2/22/2016

Additional questions submitted by vendors for the PSIM RFP. Answers are in red

ADDITIONAL CAMERAS TO BE ADDED AND INCLUDED IN THE CCTV SYSTEM

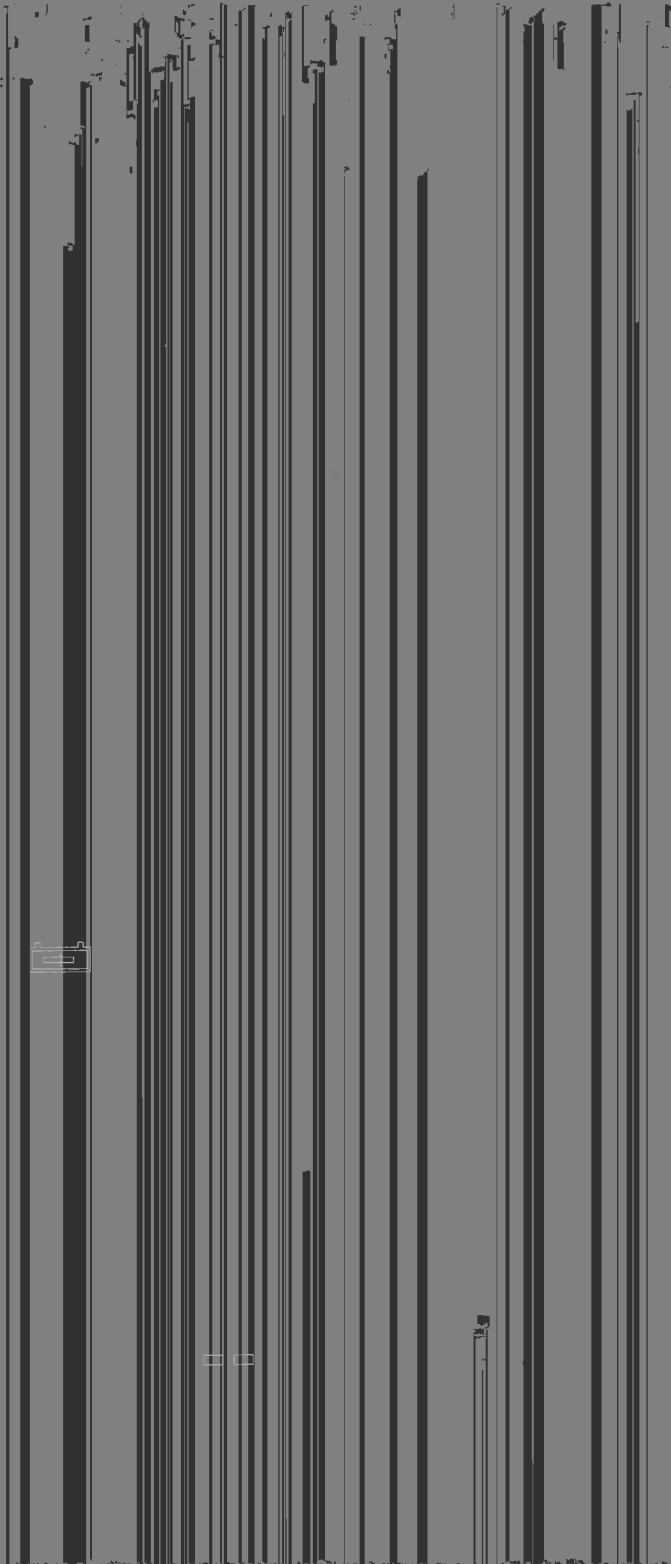
- 3) Do you want the new display camera and monitor in the corner of the desk to be incorporated into the CCTV system? **YES, AS WELL AS THE ONES IN THE DIAGRAM ATTACHED.**

Vendor to provide cameras and materials for installation.
